HOSHIZAKI AMERICA, INC.

SERVICE BULLETIN

SB07-0008

Subject: Wiring Diagram for KMD-700/900M

Fig. 1 Original wiring diagram with wrong connection on X1 terminal 4

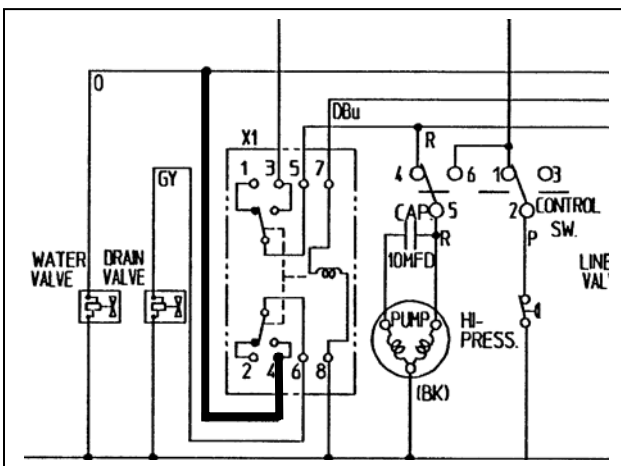
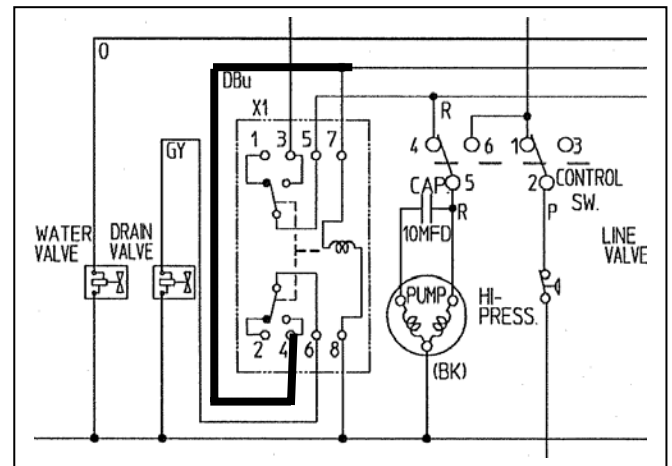
It has been brought to our attention that there is a mistake on the wiring diagram on the KMD-700/900M units. The units are wired properly from the factory and operate as designed however the diagram on the unit shows a wrong wire connection.

The problem is with the connection to X1 relay terminal number 4. It is shown connected to the Orange wire which supplies power to the inlet water valve as shown in Fig. 1 below. It is actually connected to the Dark Blue wire which energizes X1 coil as shown in Fig. 2.

If you service any KMD-700/900M product, please make the correction on the diagram using a Sharpie Permanent Marker. If parts are required for the repair, order a new diagram part number 3A2816-01 and place it over the original wiring label.

Fig. 2 Revised wiring diagram with correct connection on X1 terminal 4 to DBU wire.
